# **MELIADINE WEST GOLD PROJECT**

## **SITE WATER MANAGEMENT PLAN ADDENDUM**

COMAPLEX MINERALS CORP.  
CALGARY, AB

**September 2009**

PROJECT	MELIADINE WEST PROJECT		
PROJECT DETAIL	SITE WATER MANAGEMENT PLAN		
TITLE	Site Plan - Simplified		
DRAWING	TM, SB	DATE	Sept 2009
		PROJECT No.	3.393
COMAPLEX		COMAPLEX MINERALS CORP.	
		CALGARY - CANADA	
File:		CMF GIS Database	Figure A1

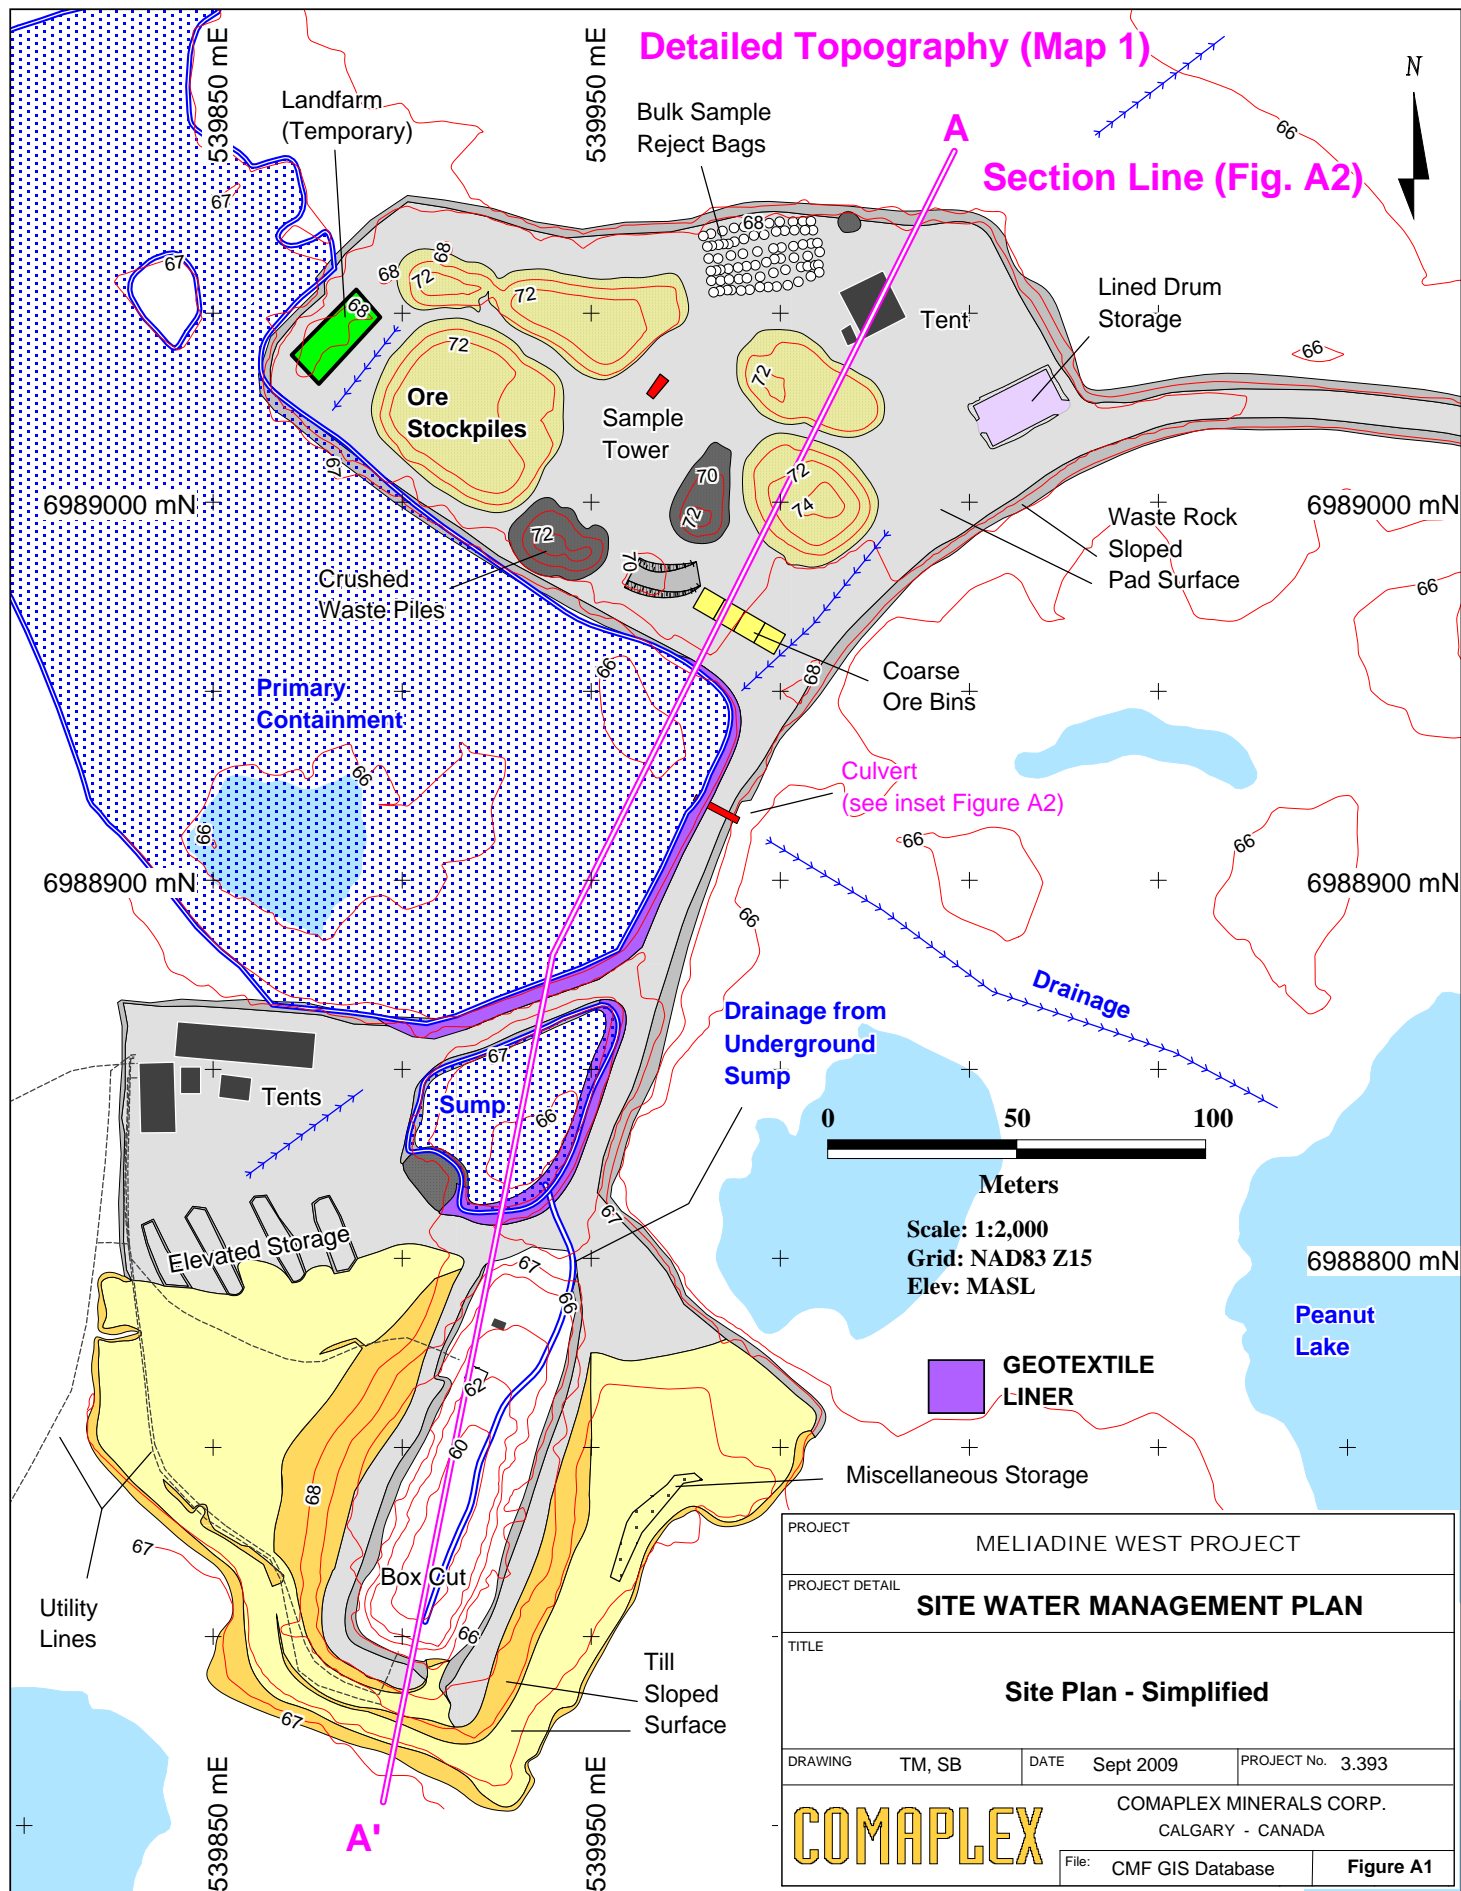
Figure A1 provides an updated simplified site plan for the underground development area at the Meliadine West Gold Project. Topographic contours shown on Figure A1 based on a site survey completed in September of 2009. Detailed topography with 10 cm contour intervals is given in attached Map A1. Figure A2 is a cross section of the underground development area giving further liner installation details. The line of the cross section is shown on Figure A1. The objectives of the plan including risks and mitigation options, and details of the properties of the installed liners are provided in the main body of the Site Water Management Plan (June 2008) and are not repeated here.

The geotextile liner installed along the southeast margins of the primary containment area and sump is shown on Figure A1 and Figure A2. Detailed installation plans are provided below:

- Personnel conversant in liner installation operated the equipment during the installation.
- The north facing slopes of the pad and roads were cut and sloped using the backhoe bucket in preparation for acceptance of the liner.
- The toe of the slope (tundra) was cleared of large rock.
- The top surface of the road and pad in this area was kept at 0.3m below grade prior to this period in anticipation of the liner installation.
- A backhoe smoothed and shaped the receiving slopes to ~ 45deg.
- A cut was made through the road and above the tundra at the position shown on the sketches to receive the culvert.
- A 3ft steel culvert was prepared with a 4" wide steel "I" beam frame welded onto the one end.
- The culvert and frame were lowered into position and <1" crushed rock was packed around the culvert to keep it in position.
